Ref: 14260.01

Re: Response to March 14, 2022 Transportation Peer Review Comments
580 Fort Pond Road

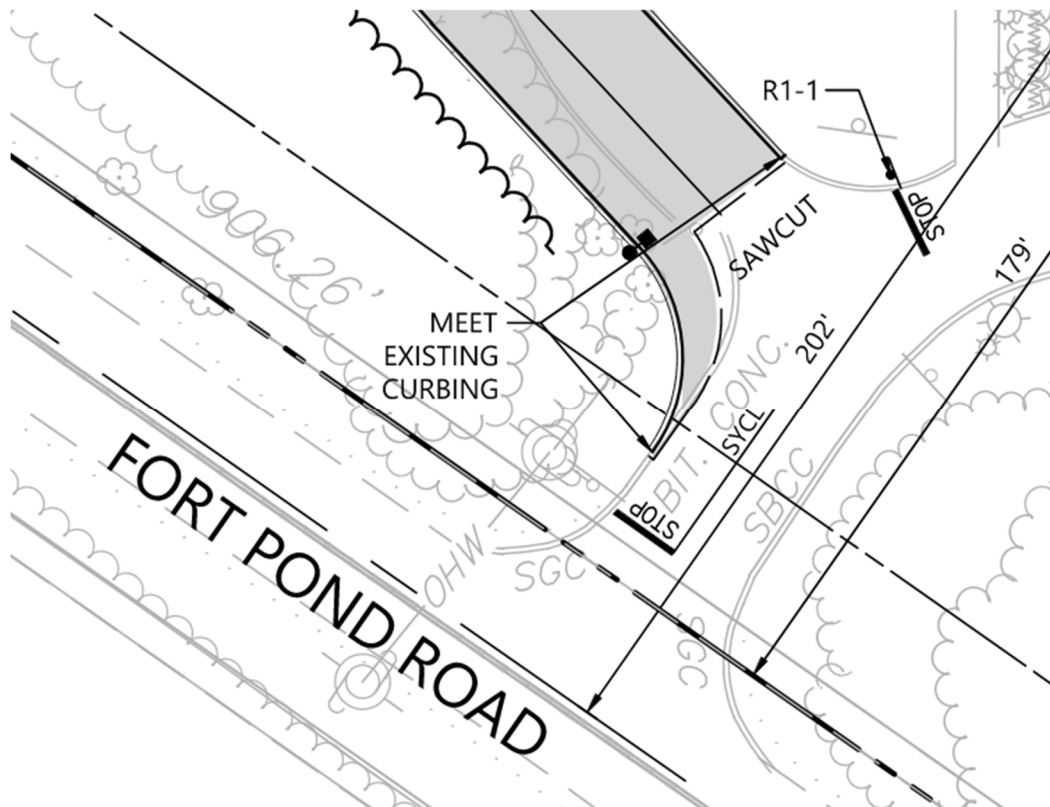
Comment 13: *"BSC recommends the applicant consider installing a solid yellow centerline line and STOP bar to supplement the existing STOP sign at the southbound approach."*

Response: The Site Plans have been updated, as shown below, to incorporate the suggested pavement markings. VHB is awaiting a vernal pool determination as part of the Conservation Commission process and will submit to the Town revised Site Plans after the vernal pool determination is made.
